STAFF REPORT
KETCHUM PLANNING AND ZONING COMMISSION
MEETING OF SEPTEMBER 15, 2020

PROJECT: 4th & Walnut Ave Commercial Development Design Review

FILE NUMBER: P20-046

APPLICATION TYPE: Design Review

LANDSCAPING PLAN

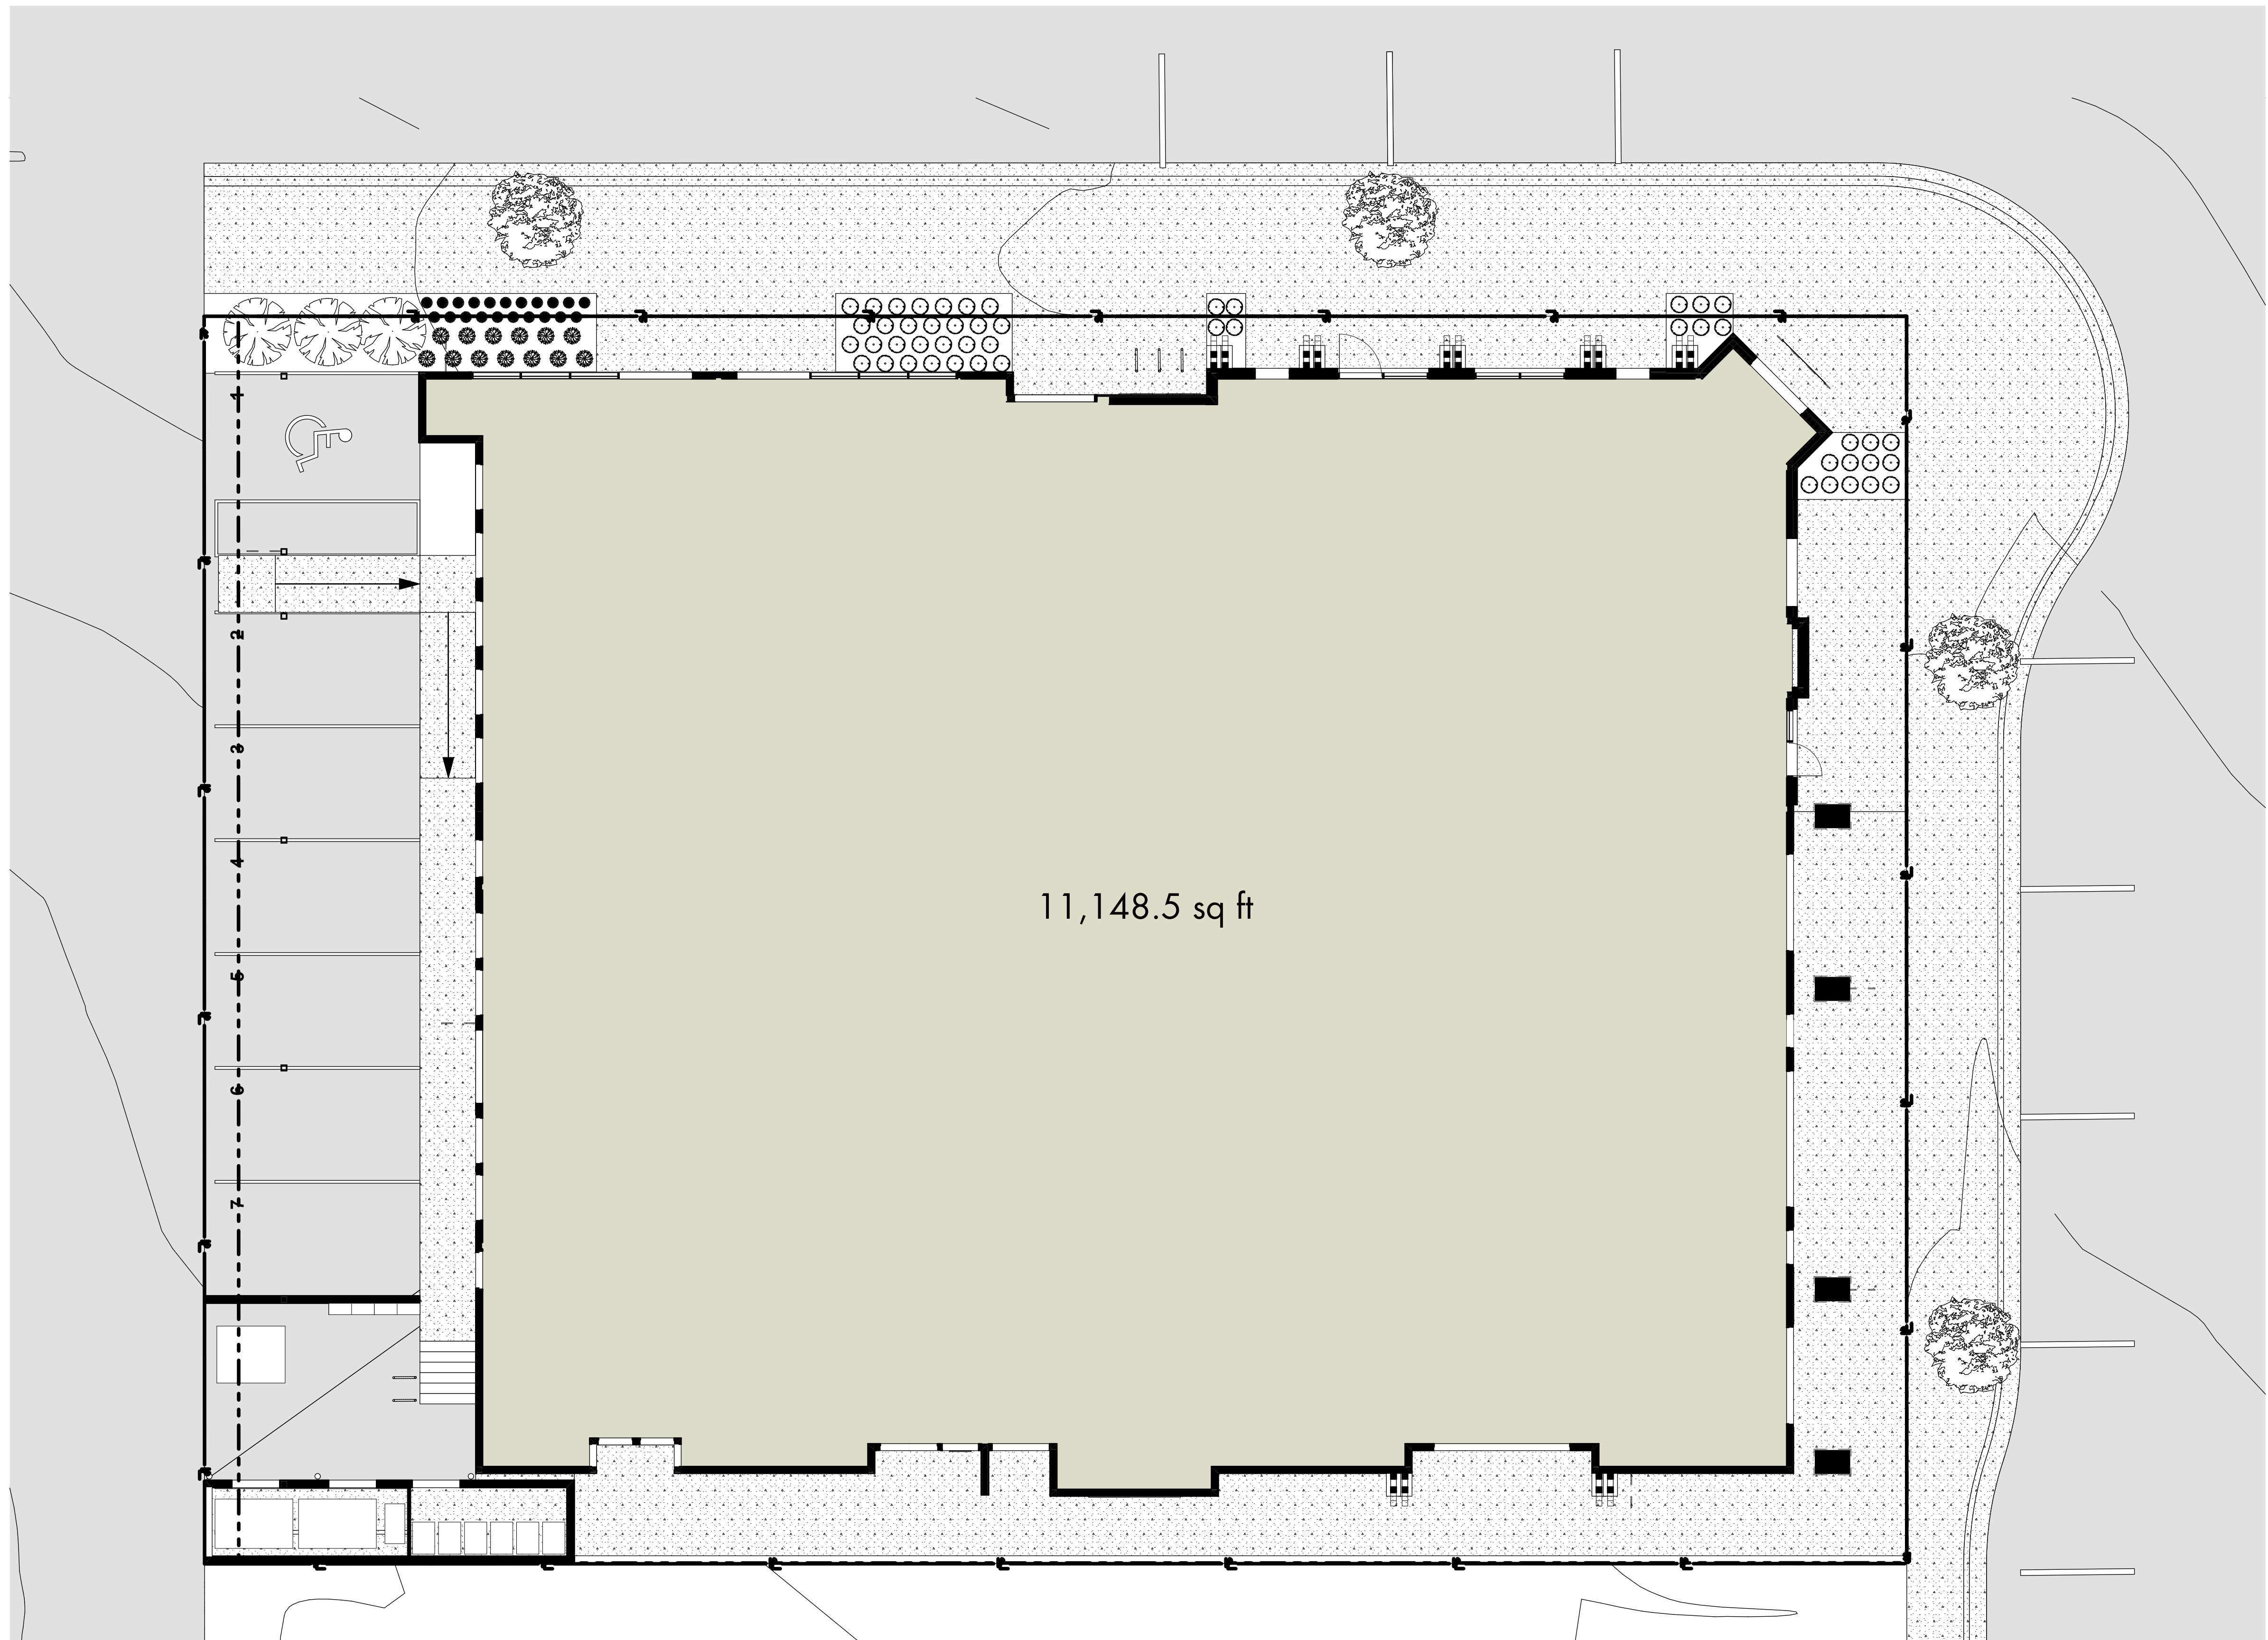
| | | | <i>Staff Comments</i> | <i>The landscape plan is indicated on sheets L-2 and L-3 of the Design Review submittal attached as Exhibit A.</i> <i>The landscape plan incorporates at-grade planters along 4th Street and Walnut Avenue. The planters will include colorful perennials and ornamental grasses that beautify the streetscape. 3 tannebaum pines are proposed on-site at the corner of 4th Street and the alley.</i> <i>The applicant has proposed four street trees within the ROW along Walnut Avenue and 4th Street. Street trees may be considered if a snowmelt system is installed for the sidewalks. Streetscape improvements must be indicated on civil plans submitted with the building permit application for final review and approval by the City Engineer and Streets Department. If approved by the City Engineer and Streets Department, all encroachments within the ROW require an Encroachment Permit.</i> |

ARCHITECTURAL SITE PLAN

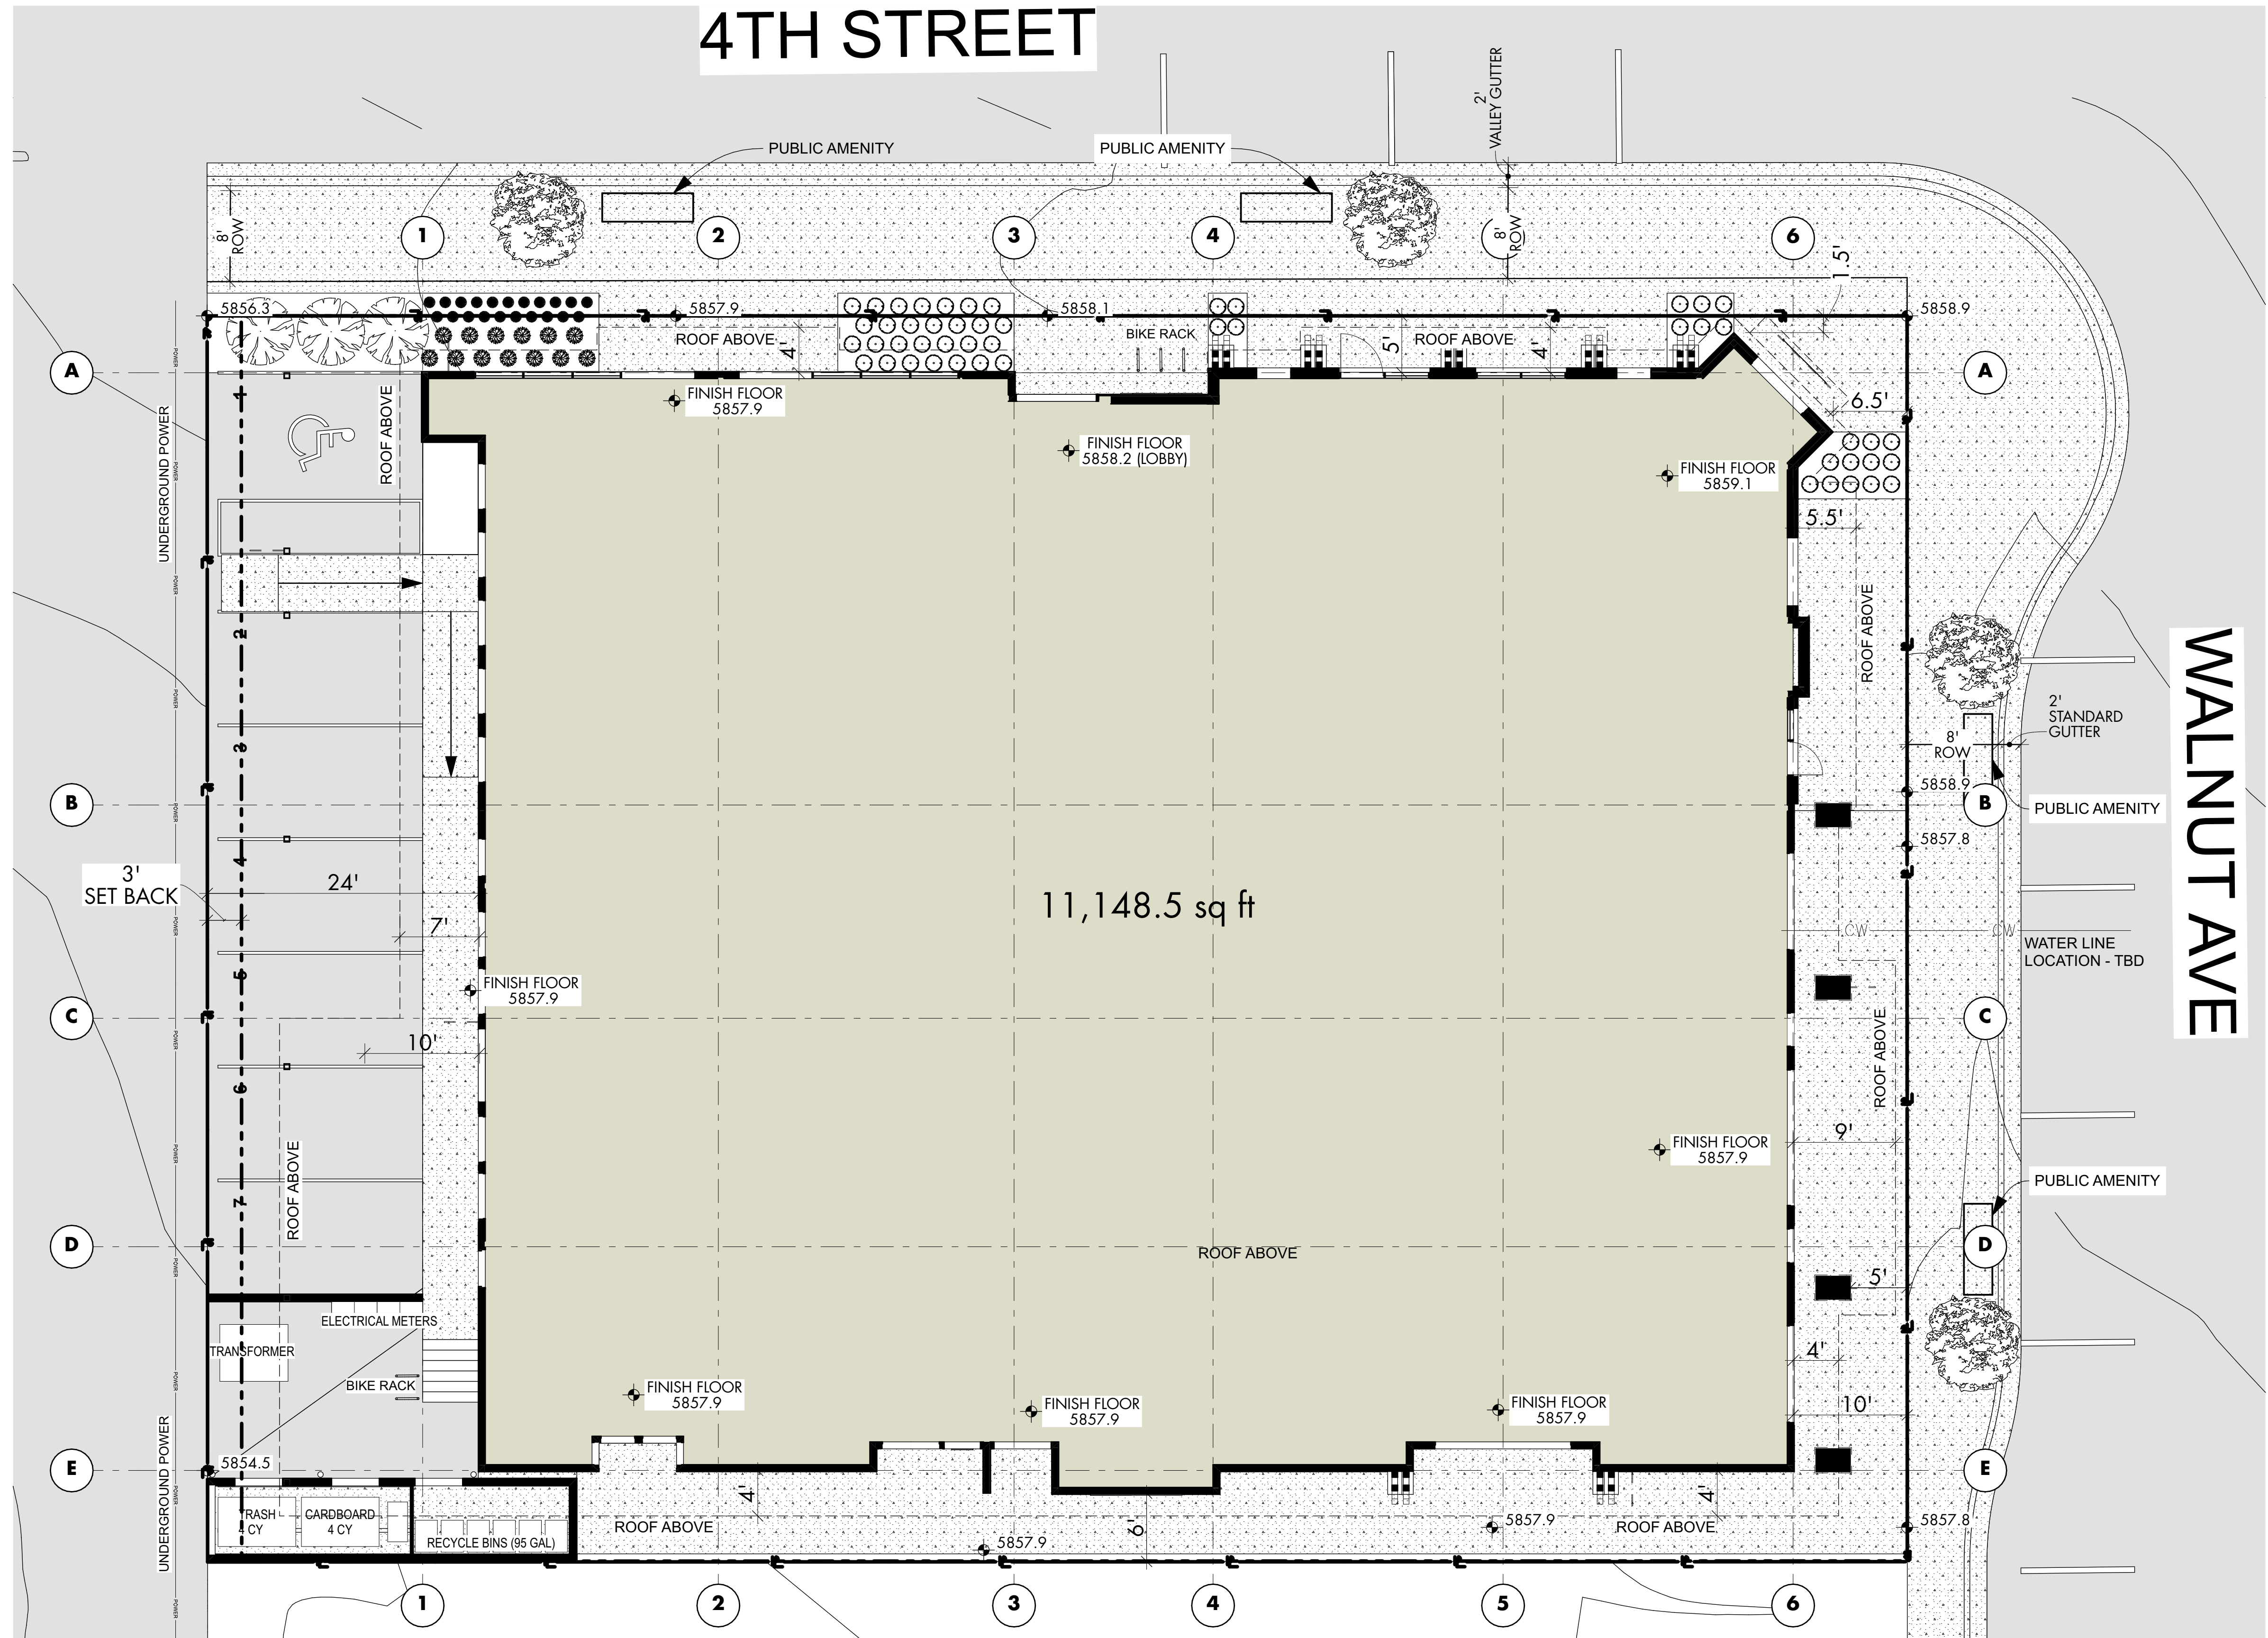
| | | | <i>Staff Comments</i> | <p><i>All utilities within the development site shall be underground and concealed from public view. The Architectural Site Plan (Sheet AS-101), First Floor Plan (A-102), and Alley Elevation (Sheet A-202) of the project plans indicate the electrical utility enclosure. The Architectural Site Plan (Sheet AS-101) indicates that the transformer serving the development will be located at the back of the building adjacent to the Block 44 alleyway and fully concealed from public view.</i></p> <p><i>An existing overhead power line runs along the Block 44 alleyway adjacent to the subject property. The project plans indicate that this power line will be buried underground.</i></p> |

| | | | <p><i>Staff Comments</i></p> <p><i>The Architectural Site Plan on Sheet AS-101 of the project plans note that snowmelt and hauling snow off-site is proposed in lieu of providing snow storage areas on-site.</i></p> <p><i>Most of the on-site circulation areas are covered by roof overhangs and canopies. Snow removal from the sidewalk along 4th Street and Walnut Avenue will be the responsibility of the property owner.</i></p> <p><i>The applicant proposes to snowmelt or haul snow off-site, which is permitted as an alternative to providing a snow storage area by KMC §17.96.060.H4.</i></p> | |

| | | | <i>Staff Comments</i> | <i>The Architectural Site Plans on Sheet AS-101 notes that snow management will be accomplished by snowmelt and hauling snow off-site. Most of the on-site circulation areas are protected by roof overhangs and canopies. Snow removal from the sidewalk along 4th Street and Walnut Avenue will be the responsibility of the property owner.</i> |
